PLANNING BOARD REPORT PORTLAND, MAINE

New Yard at Canal Landing
Boatyard and Boat Repair Facility
40 West Commercial Street

Level III Site Plan, Conditional Use, Shoreland Zone, Flood Plain,
and Site Location of Development Reviews

Submitted to: Portland Planning Board: Public Hearing Date: December 18, 2012 Project #2012-575 CBL: 59-A-1,2,3,4,5,6,7,8,9,10,11,12	Prepared by: Bill Needelman, Senior Planner Date: December 14, 2012 Planning Board Report Number: #53-12
---	--

Staff has provided a map of the interim pedestrian route below.

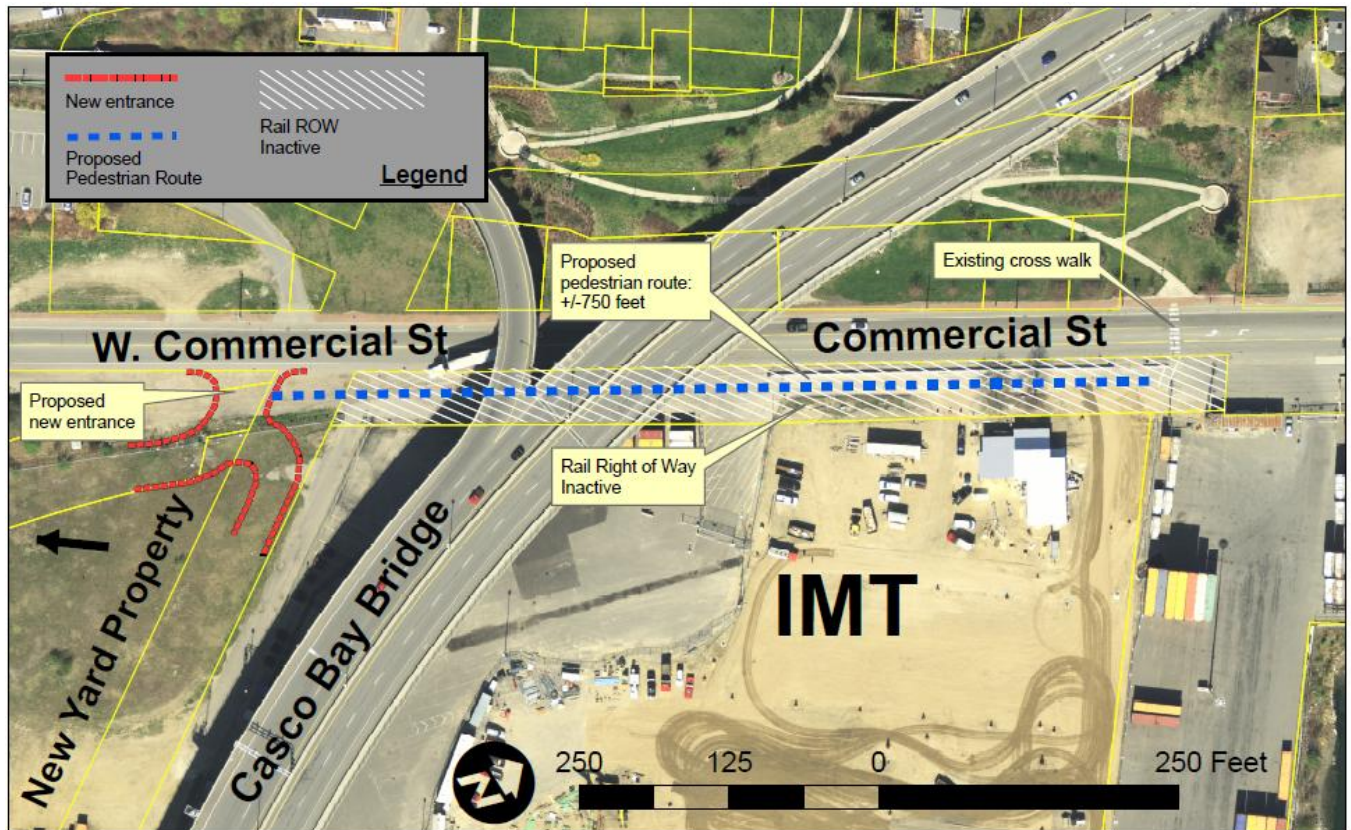
As an interim, the applicant proposes that pedestrians who choose to access the site by foot can use the inactive rail line that runs from the subject site, in front of the IMT, to a mid-block crosswalk located near the easterly end of the IMT boundary with Deake's Wharf. While not ideal, this would appear to be the only reasonably safe access to the existing sidewalk network – with or without a sidewalk on the subject site.
